DESIGN PH	DRAWN BY PH	DART AEROSPACE USA, INC. PORT HADLOCK, WA	
CHECKED 	APPROVED 	DRAWING NO. DSI 9364	REV. A SHEET 1 OF 1
DATE 07.01.16		TITLE BUSHING INSTALLATION	SCALE NTS
A	07.01.16	NEW ISSUE

DART SERVICE INSTRUCTION

TO AMEND IIN-D412-742 REV. B AND ICA-D412-742 REV. 1

REF. FAA STC: SR01583SE

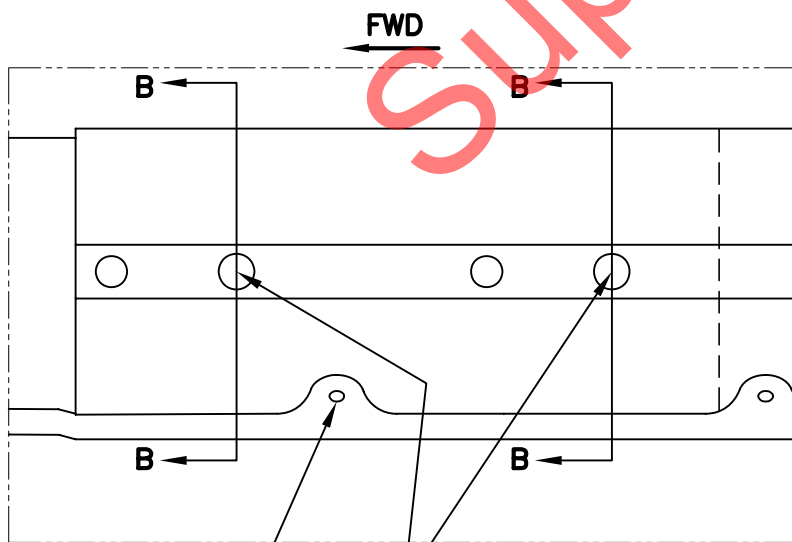
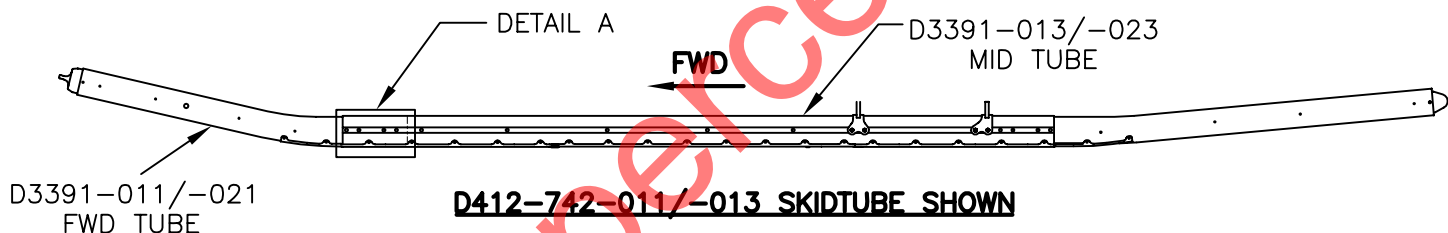
TO PREVENT THE D3391-011/-021 FWD TUBE FROM MOVING WITH RESPECT TO THE D3391-013/-023 MID TUBE, CUSTOMERS RECEIVING D412-742-011/-013 SKIDTUBES AT CHG 002 HAVE A D3591-1 BUSHING INSTALLED AT THE FWD SADDLE HOLES AS SHOWN IN DETAIL A (2 PLACES).

- 1) REMOVE SKIDTUBE/SADDLES FROM AIRCRAFT USING SECTION 32.7 OF ICA-D412-742 AS A GUIDELINE.
- 2) TRANSFER DRILL 1/2" HOLES ($\varnothing 0.500$) INTO THE FWD SADDLE HOLES AT THE LOCATIONS SHOWN (2 PLACES) THRU THE D3391-013/-023 MID TUBE AND D3391-011/-021 FWD TUBE. **DO NOT OPEN UP HOLES IN D2571/D2572 FWD SADDLES.**
- 3) REMOVE FWD TUBE FROM MID TUBE, DEBURR DRILLED HOLES, TOUCH UP HOLES WITH MIL-P-85582 OR MIL-P-23377 PRIMER
- 4) RE-INSTALL D3391-011/-021 FWD TUBE INTO D3391-013/-023 MID TUBE USING SECTION 32.7 OF ICA-D412-742 AS A GUIDELINE EXCEPT INSTALL D3591-1 BUSHINGS AS SHOWN IN DETAIL A USING LPS LABORATORIES LPS-3 CORROSION INHIBITOR PRIOR TO INSTALLING THE D2571/D2572 SADDLES.

DETAIL A: D3591-1 BUSHING INSTALLATION LOCATION

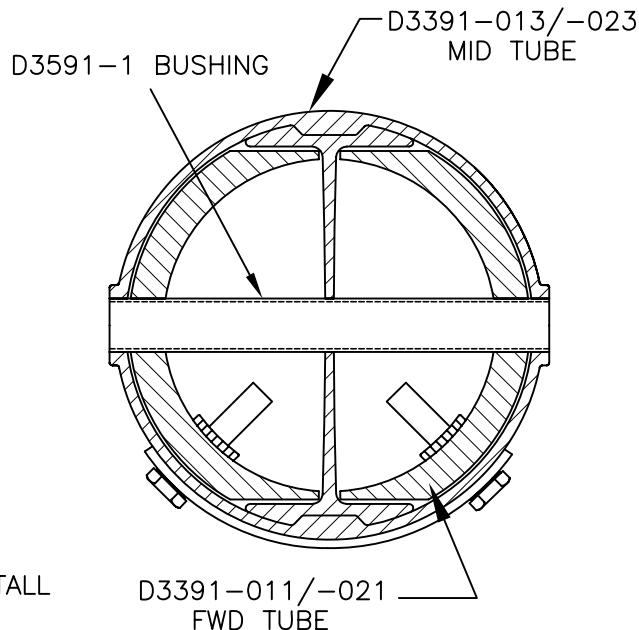
ENSURE BOLT IS FASTENED
PRIOR TO TRANSFER DRILLING
(REF)

OPEN TO $\varnothing 0.500$ AND INSTALL
D3591-1 BUSHING
(2 PLACES)
